Department of Transportation

MEMORANDUM

SUBJECT: ZC Case No. 22-08 – 4401-4435 Benning Road NE

Figure 1 | Site Plan

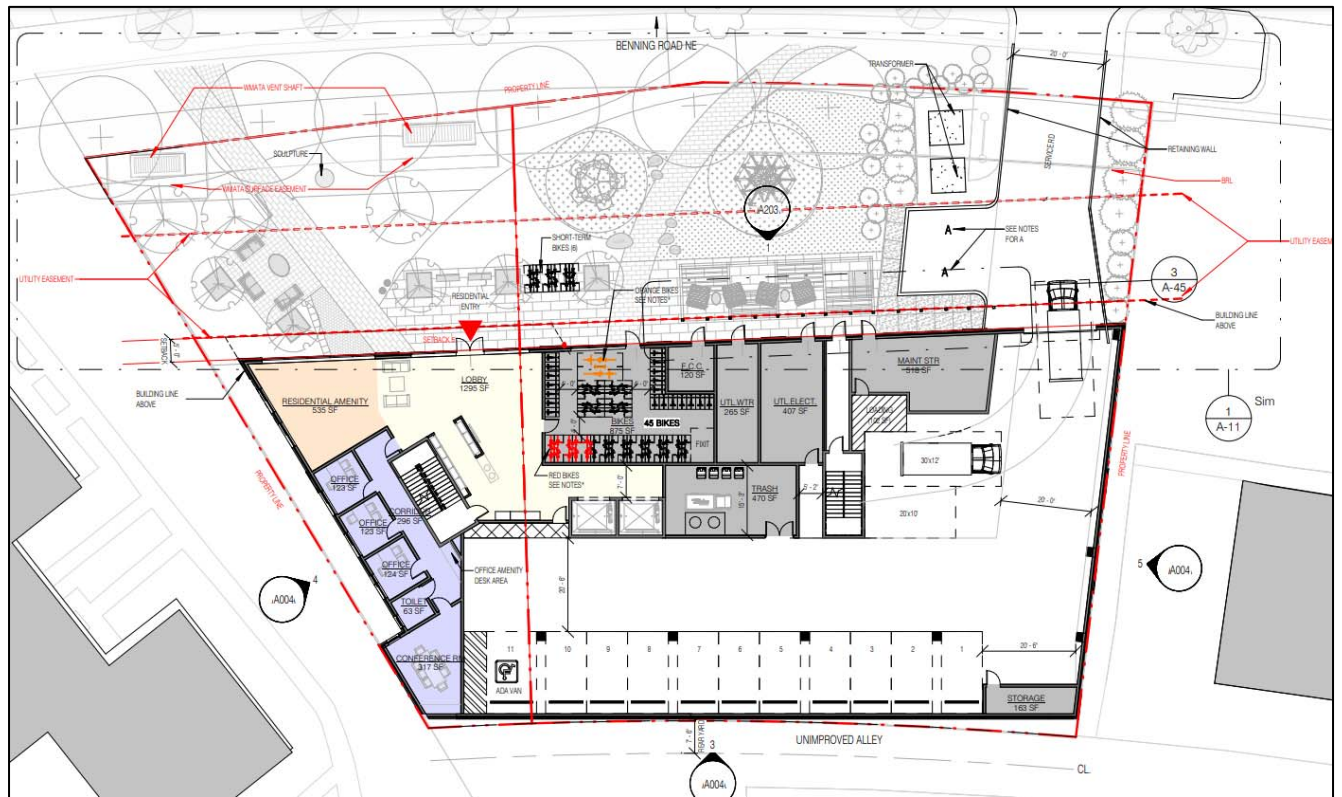
While the preliminary public space plans, shown above in Figure 1, are generally consistent with DDOT standards, there are several considerations that need to be reviewed in greater detail during the public space permitting process:

- There is a 15-foot Building Restriction Line (BRL) along the Benning Road frontage. The area between the BRL and property line is the building restriction area and is regulated like DDOT public space. This area is intended as greens pace and should remain park-like in nature with landscaping;

- The proposed curb cut should not exceed 24 feet in width and will need to be approved by the Public Space Committee. Ensure there are adequate pedestrian facilities crossing the driveway;
- The transformers, vaults, and two (2) surface parking spaces should be screened from the sidewalk with vegetation. Additionally, DDOT could support the Applicant providing art wraps around the transformers as part of the Arts in the Right-of-Way (AROW) program, with WMATA's approval;
- Lead walks should not exceed 6 feet wide in public space;
- Fencing for the tot lots should not exceed 42 inches in height; and
- The design of the sidewalk and tree box zone should be constructed consistent with the Benning Road Bridges and Transportation Improvements Project.

Figure 4 | Existing Pedestrian Network

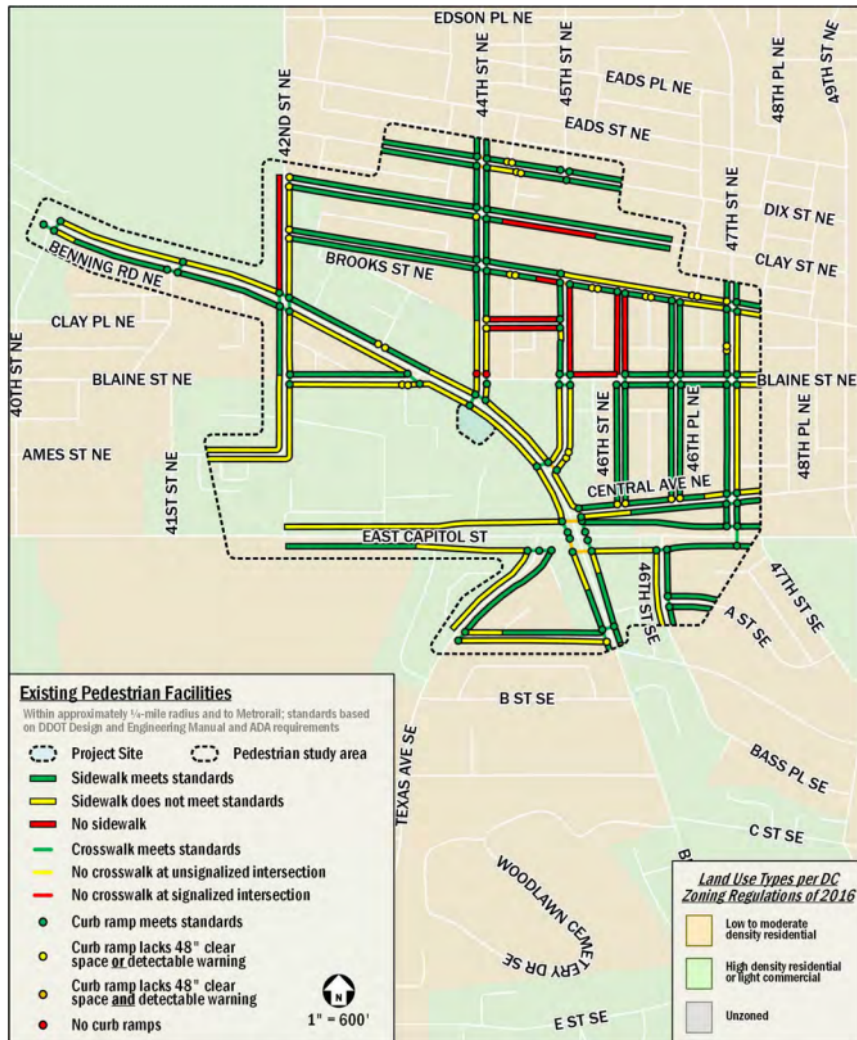
The Applicant’s inventory of existing pedestrian infrastructure, as shown in Figure 4 below, demonstrates that some sidewalks in the immediate vicinity of the site do not meet DDOT standards. Many of these deficiencies will be addressed during construction of the next phase of the Benning Road Bridges and Transportation Improvements Project.
